Determination 2018/032

Regarding open risers in an existing building undergoing alterations at 13B Wall Place, Kenepuru, Porirua

Summary

Figure 1: Sketch of stair A-A including closer (as proposed in building consent⁶)

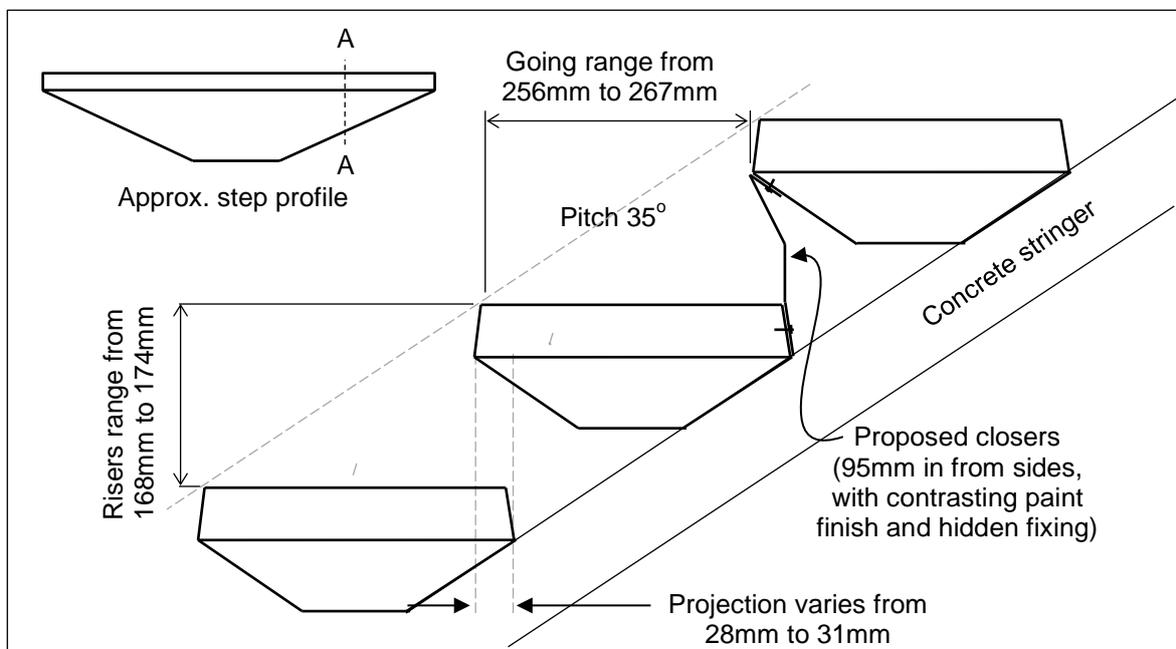
These stairs MUST be compliant (also noted in the fire report) as is on the accessible route – No open risers are permitted in compliance with NZBC D1.1c, D1.3.1c, D1/AS1 – 4.1.8b and NZS4121:2001⁵ – C8.1.1. Please provide details on method of installing closed risers to the stair.

The proposal to keep the stair risers open does not comply with [Clause C4.2 or D1]. I noted (*sic*) this stair was considered ANARP previously when the other stair components were installed as part of the seismic upgrade circa (2014).

[The authority suggests] the open risers can be closed for example with the addition of sheet metal or timber components and while this may not be straight forward and may not be continuous but will make the stairs usable as the leg/foot can be dragged using the closer as a guide. ...

... the reinforcing steel at both nosing and rear of each tread has been placed with very tight concrete cover dimensions.

In our opinion, the fixings of front or rear mounted “closers” will run the risk of splitting concrete off corners, or failing to achieve suitable penetration.

- 4.3.6 The stair has a maximum tread projection of 31mm, an open riser, and a tread with a 35° return angle¹⁰ under the tread at its centre (the treads taper in depth so the return angle is in effect 90° at the edges of the stair). This configuration can allow a foot to be caught under the tread when going up the stairs (refer Figure 13 in D1/AS1). This matter can be improved though the installation of closers, as described in the building consent.

- 4.4.8 The applicant has received advice from an engineer that the closers as proposed with mechanical fixings (see Figure 1) ‘will run the risk of splitting concrete off corners, or failing to achieve suitable penetration’. I accept that the reinforcing steel closely adjacent to the front and rear faces of the treads will limit the ability to install mechanical fixings at these points. The architect is also of the view that using adhesive fixings would not be a durable solution and not practically feasible. In regards to the option set out by the authority to amend the design of the closers, the architect stated:

4.4.12 However, during the course of the determination the architect has provided an estimate for fabrication and installation of closers that was proposed for the purpose of obtaining the building consent. I note that the fabrication of the closers would be adversely impacted by the risers not being uniform, but more notably by the somewhat complex form of the underside of the treads which tapers in profile along its length. I also note that the closers as described in the approved consent do not provide a buildable solution.

Figure 2: Sketch of possible closer solution using folded sheet metal

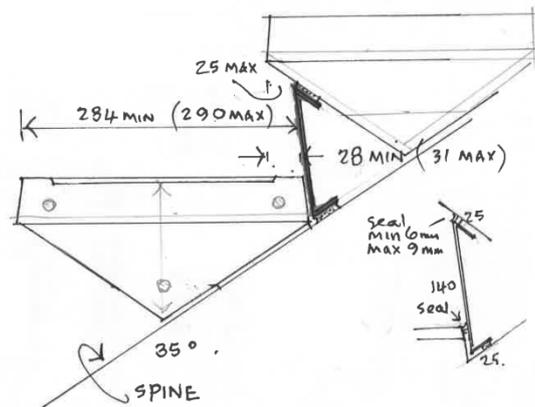
4.4.13 Although the solution that formed part of the approved consent is considered unworkable I am of the opinion there are other solutions available to the owner that could have been further explored. For example, one possible solution consists of folded metal secured using adhesive sealant as described below (refer also sketch in Figure 2):

- limiting the width of the closer to the central portion¹³ of the stair
- securing a folded return at the bottom edge of the closer to the top of the 400mm wide stringer at the rear of each tread (the closer could run past the edges of the stringer)
- securing a folded return at the top edge of the closer to the underside of the tread above (and a maximum 25mm back from the front edge of the tread).

4.4.14 The above may provide a workable solution and informs my conclusion that a feasible solution, whether this or another one, could be designed to close the risers. As noted in paragraph 4.4.8, the architect considers an adhesive sealant used in this situation would not be sufficiently durable; however, the sealant fixings can be configured so they are in compression when impacted by foot traffic which would provide a more durable solution.
